CITY OF SAN ANTONIO

Re: **Triana Subdivision**

MDP# 004-06

The City Staff Development Review Committee has reviewed **Triana Subdivision** Master Development Plan **M.D.P.# 004-06**, please find enclosed a signed copy for your files. Your plan was accepted however please note the following:

MASTER DEVELOPMENT PLAN
TRIANA
 (FORMERLY KNOWN AS LOS REYES CROSSING)
 Bexar County, Texas

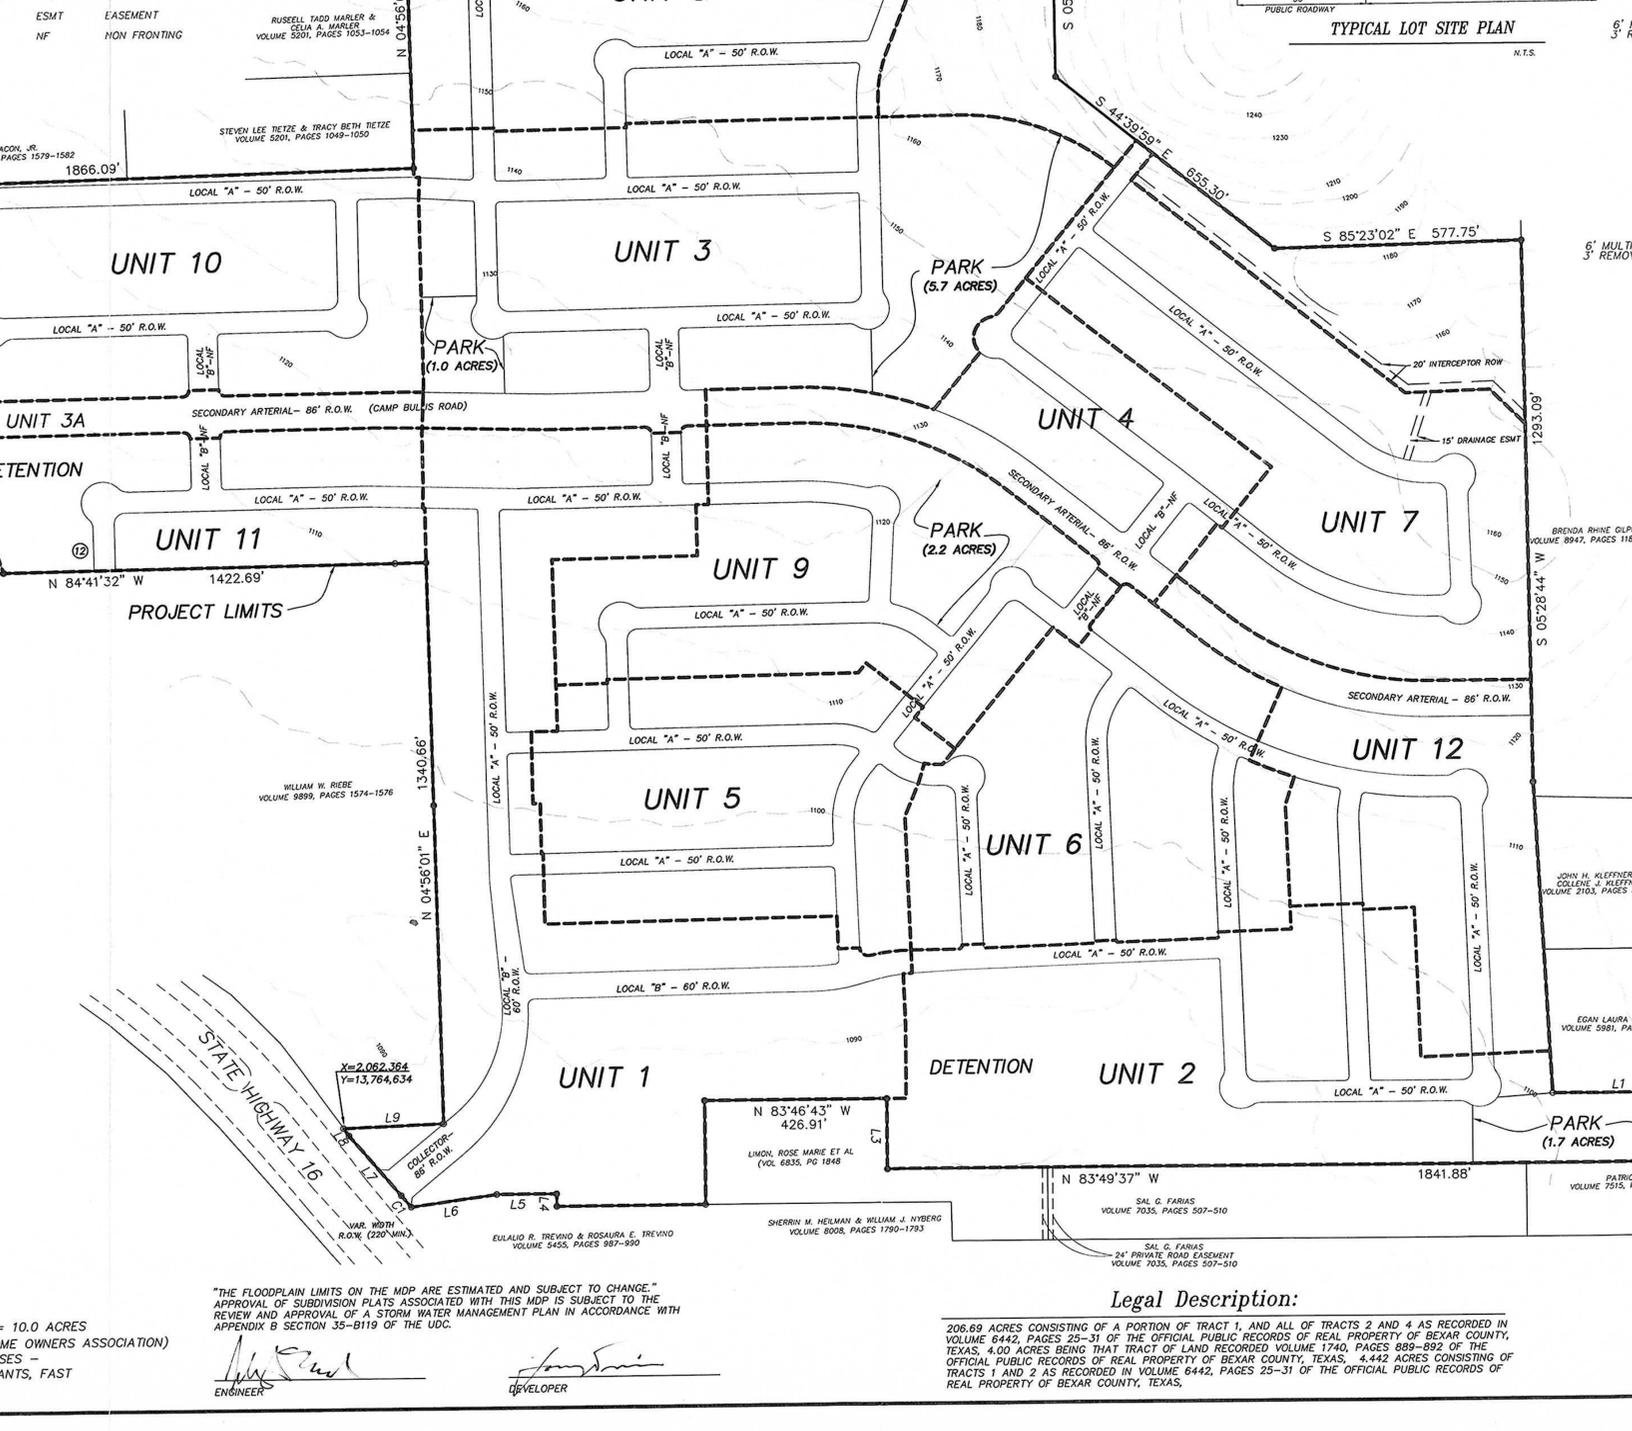
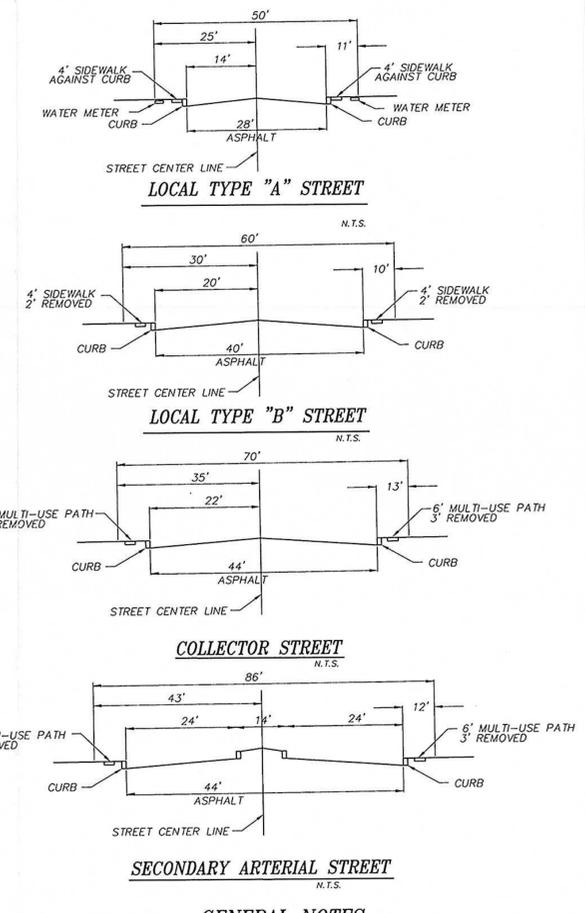
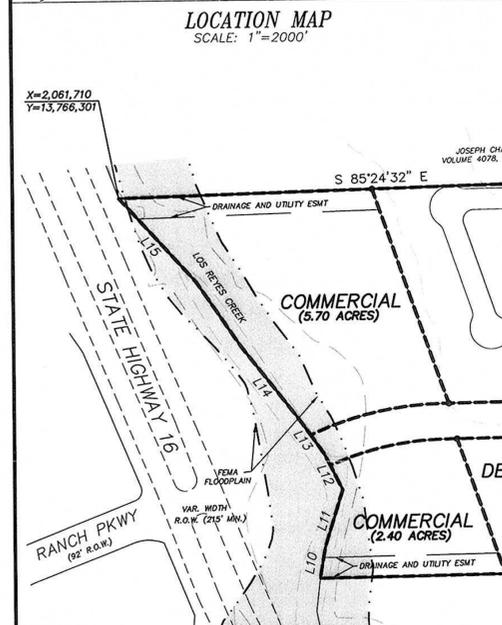
- In consideration of public safety and convenience, excessive grades by reason of topography should be avoided in street layouts and arrangements.
- Any access and R.O.W. issues along state facilities will need to be resolved with the **Texas Department of Transportation (TXDOT)**. For information about these requirements you can contact TXDOT at 615-5814.
- **SAWS Aquifer Protection and Evaluation** will require the following pursuant to the Aquifer Protection Ordinance No. 81491, for Plat Certification.
 1. 100 year Flood Plain Shown and Buffing (if applicable)
 2. Sensitive Recharge Features and Buffing (if applicable)
 3. Category Letter for All Site Specific Plats (if Category 2 or 3, an Aquifer Protection Plan is required)
 4. According to the Water Quality Ordinance # 81491, Section 34-914, buffering may be required.

Additionally, a Water Pollution Abatement Plan or Contributing Zone Plan must be submitted and approved with the Texas Commission on Environmental Quality (TCEQ) prior to construction.

Historical Preservation: The Texas Sites Atlas indicates that no archaeological sites have been previously identified within the above referenced property. A **historic agricultural complex with one standing stone structure** believed to date to the late 19th-century has been identified. Additionally, staff of the HPO believe there is a **high probability** that the property may contain

sites, some of which may be significant. Thus, before any work that might affect any sites is begun, we recommend that qualified professionals conduct an archaeological/architectural investigation of the property.

An administrative variance will be required from Bexar County at the time of planting strips between the curb and sidewalks of Local B, Collector and Arterial roadways.

All access to SH 16 adjacent to this site are recommended to be upgraded with exclusive right-turn lanes as per TxDOT standards.

Secondary access must be secured prior to the approval of any plat or combination of plats exceeding 125 dwelling units as per UDC 35-506(e)(7).

Traffic controls shall be warrants as per the Texas Manual on Unified Control Devices and Approved by TxDOT and / or Bexar County.

It is understood that this MDP is a conceptual plan and controlled access should be maintained in order to uphold safe and efficient traffic flow. Therefore, the developer of this property is encouraged to design common access and shared driveways between all proposed commercial lots. Bexar County reserves the right to address Driveways, Street Design, Sight Distance, ADA requirements, Drainage and Flood Plain issues at the time of platting.

- It will be expected that you will plat all of the property depicted in your Master Development Plan (M.D.P.), to include floodplains, drainage areas and open space.
